Change Notice

FT Series

Changes to Connectors on Touch Screen Controller Board

Changes for FT Controller Board
FTCS05B Shown

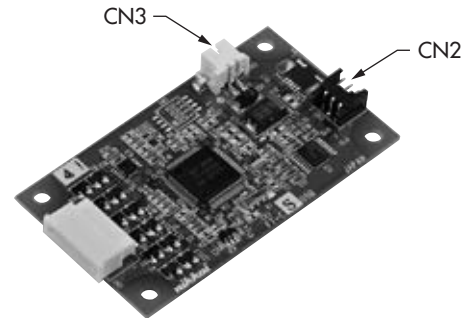
There will be revisions to the connectors for the FT Series Touch Screen controller board for RS232C. The changes will be for the header connectors for CN2 and CN3, and will effect standard part numbers (listed below) and custom part numbers.

Changes for Touch Screen Controller Board		
Part Number	Before Change	After Change
FTCS04A FTCS04A2	CN2: Hirose DF3Z-3P-2H(20) CN3: Hirose DF3Z-2P-2H(20)	CN2: Hirose DF3E-3P-2H(20) CN3: Hirose DF3E-2P-2H(20)
FTCS04B FTCS05B	CN3: Hirose DF3Z-2P-2H(20)	CN3: Hirose DF3E-2P-2H(20)
